**ADDENDUM to TECHNICAL DRAINAGE STUDY
FOR
824 South Decatur Blvd.
(Update for Goal Extended Stay)**

**JOB NO. 210261
September 2022**

3rd Submittal: Update #1

**Subject: Addendum to Technical Drainage Study for 824 South Decatur Boulevard (Update for
Goal Extended Stay)
CLV #DS4956C**

COMMENT #1

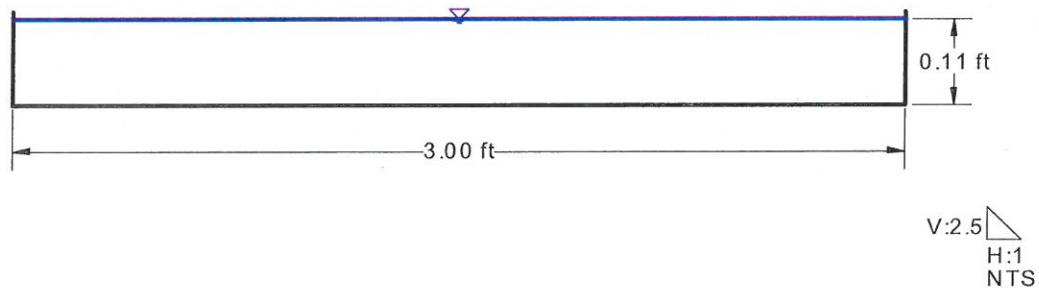
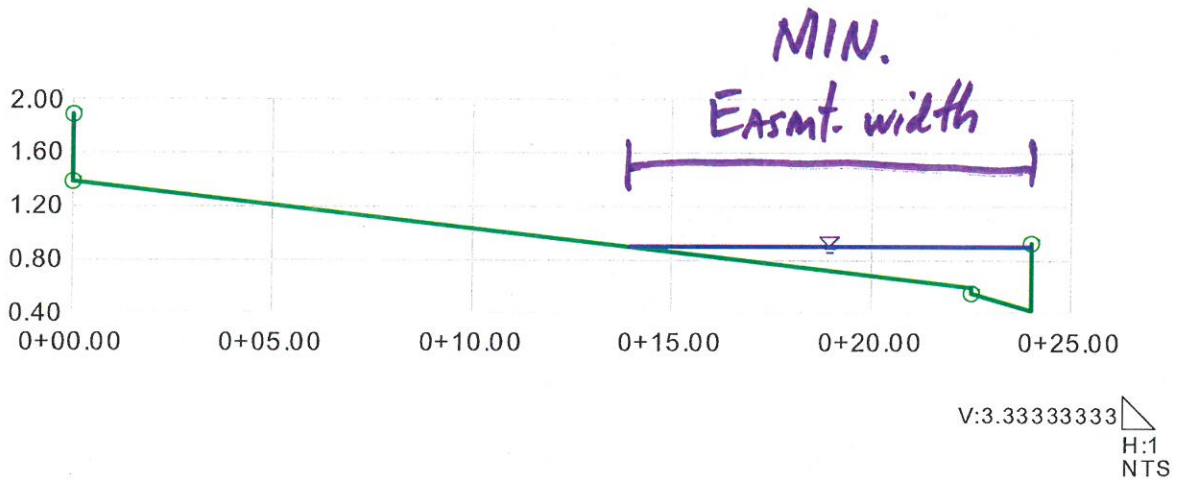
1. *FIG 5 (Developed Condition Basin Map): Hydraulic Section 1 is not found in any of the Summary Tables. Address and revise in the next submittal.*

Response: The Section 1 is in the Summary Table. It was just mislabeled as 1A and 1B. Also, please note that Section 2 was revised due to the design change for the easement flow to be in the drive aisle instead. A hydraulic section has been included at the upstream side of the building to show the FF is 18" above the 100yr flow depth suing the easement flow (4.20cfs). A section of the 3ft U channel has also been included for where the easement flow enters the site. A proposed drainage easement has been provided. See Plans and revised Figure DR5.

← Easement Flow thru wall opening

← Easement Flow thru wall opening

COMMENT #4

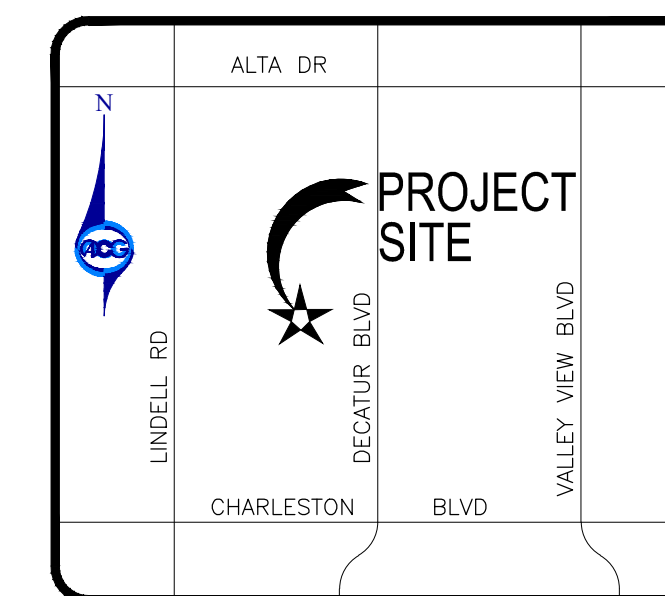
- For parking lot LID and storm water quality, the engineer must provide calculations (per *Section 1500 of the CCRFCD Hydrologic Criteria and Drainage Design Manual*) to justify that the length, width and depth of the landscape swales are meeting the design guidelines in an effective disconnected impervious areas layout.

4. For parking lot LID and storm water quality, the engineer must provide calculations (per Section 1500 of the CCRFCD Hydrologic Criteria and Drainage Design Manual) to justify that the length, width and depth of the landscape swales are meeting the design guidelines in an effective disconnected impervious areas layout.

Response: Noted. A BMP calculation spreadsheet has been provided. The BMP swales are treating 100% of the impervious site.

Hence, approximately 100.0% being treated of the Total Parking Lot Area

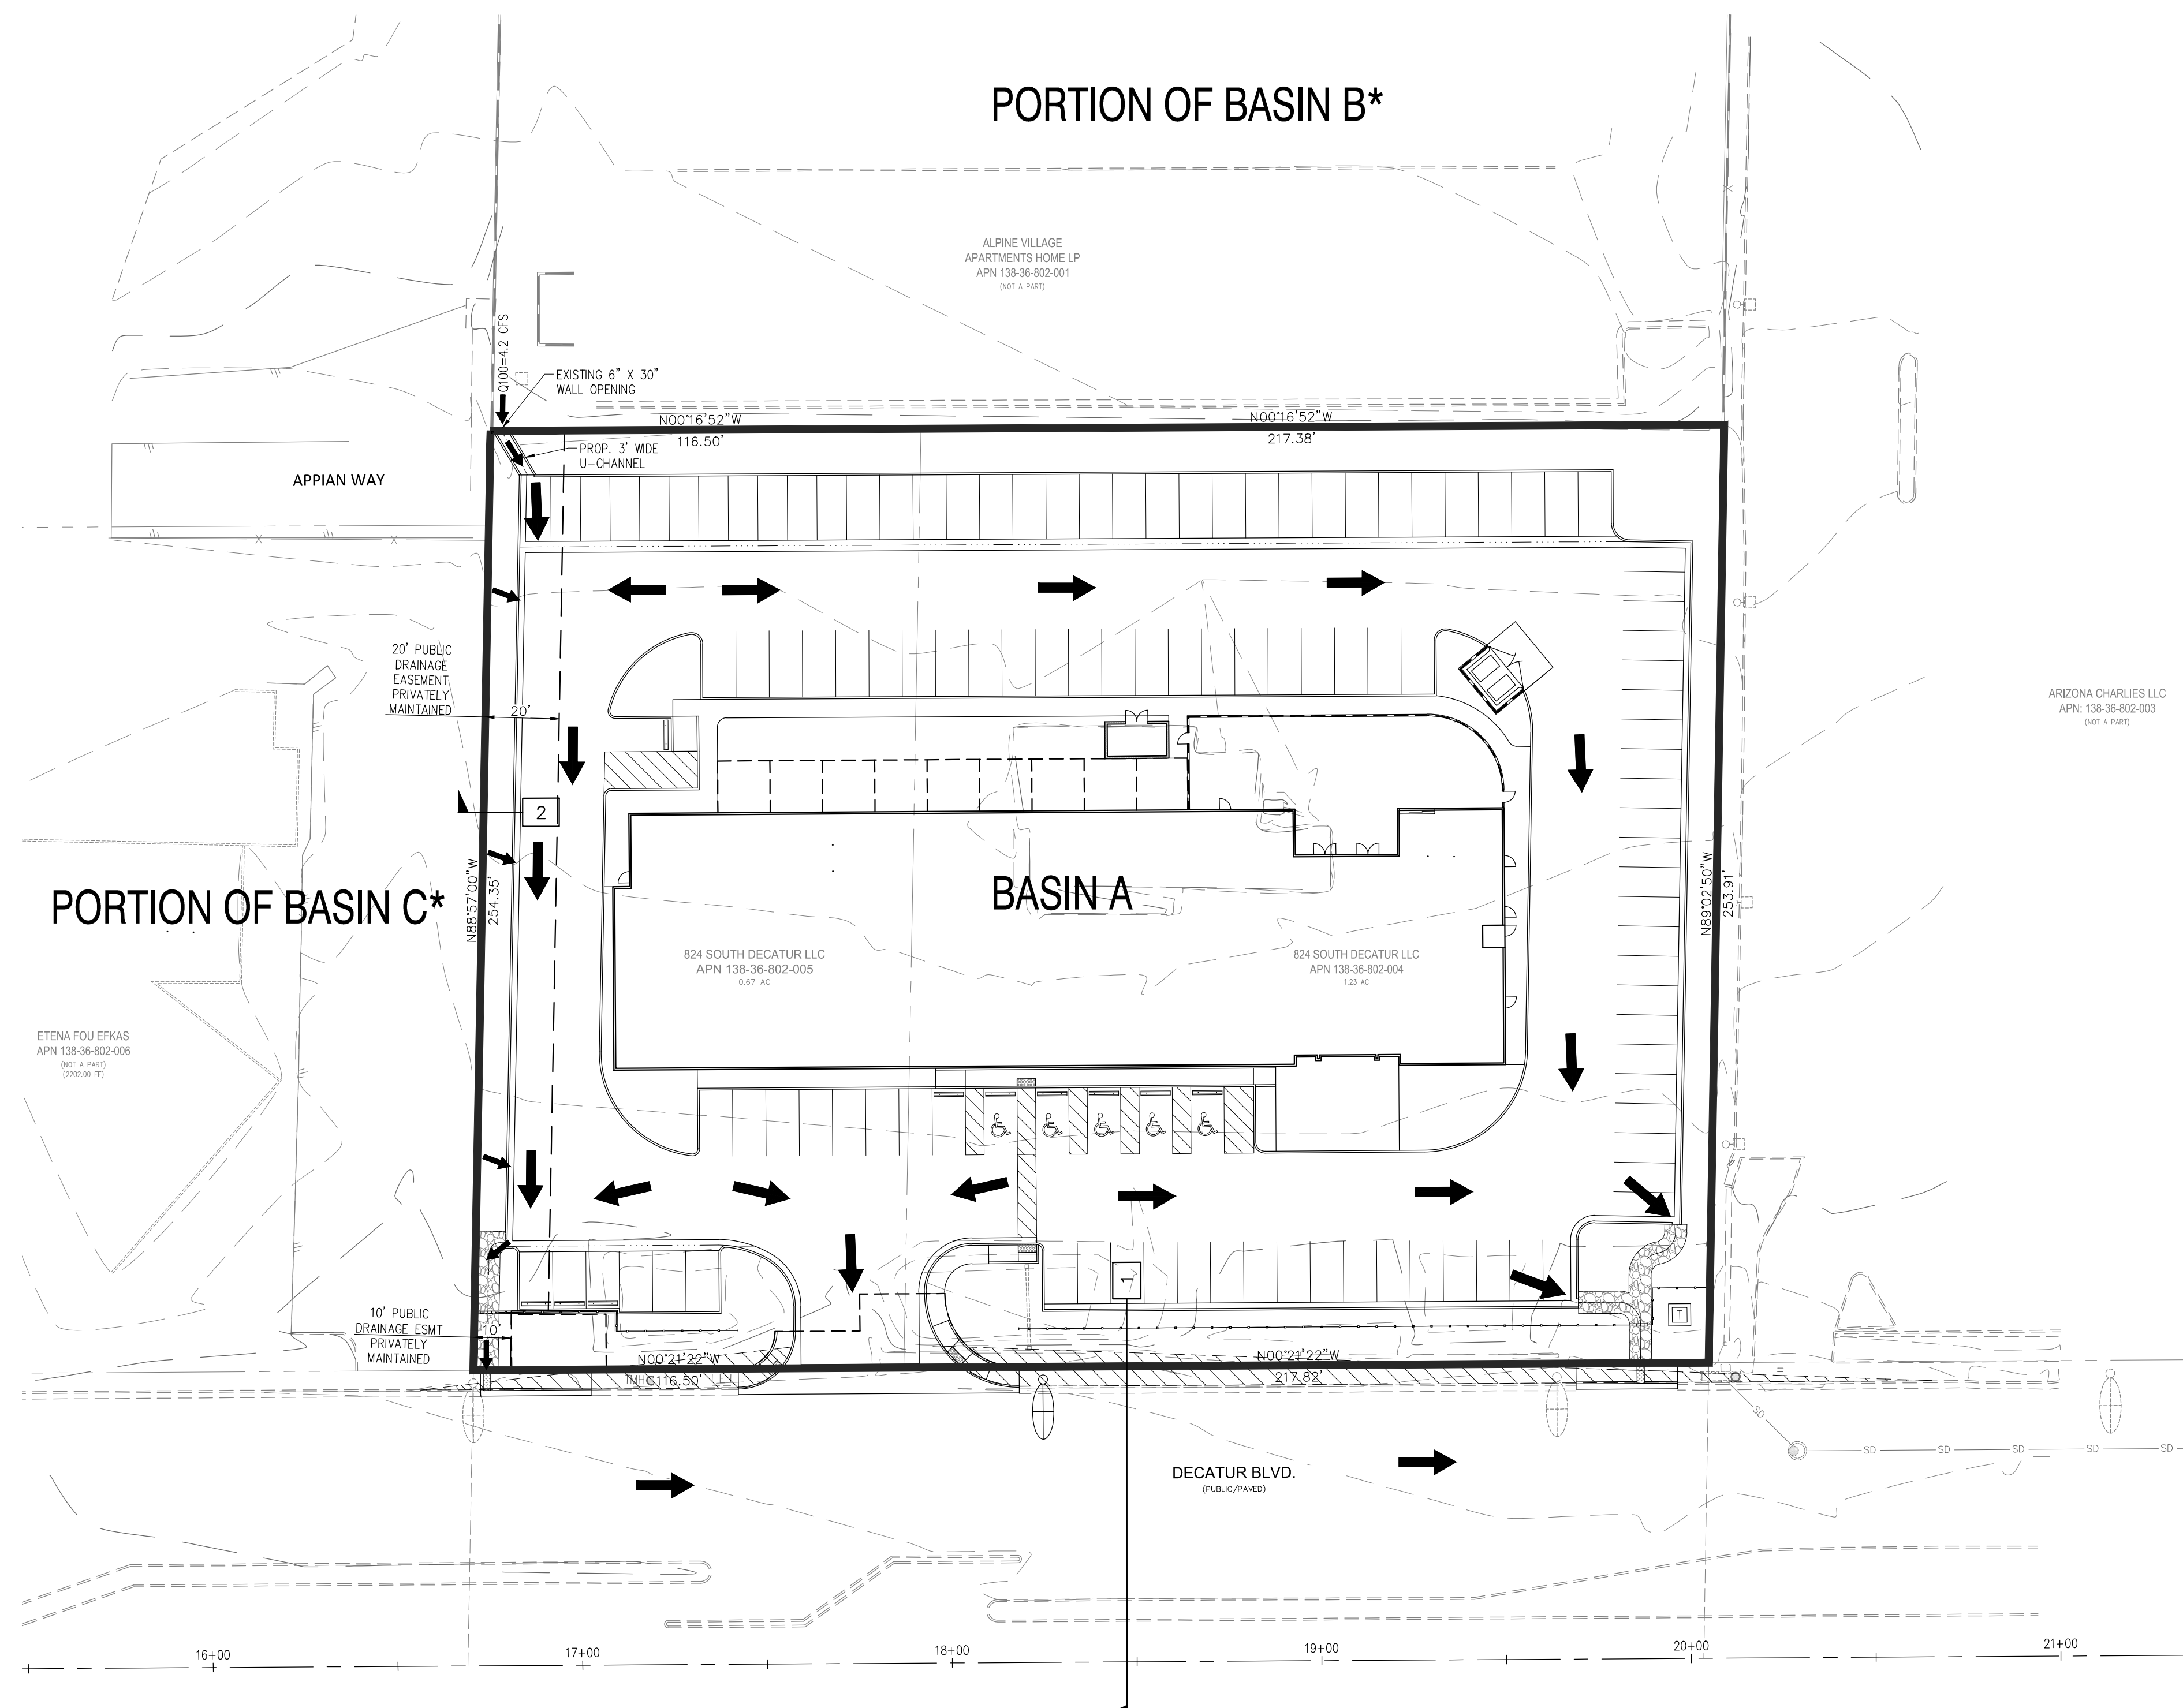
- FIG 5 (Developed Condition Basin Map):** *Hydraulic Section 1* is not found in any of the *Summary Tables*. Address and revise in the next submittal.
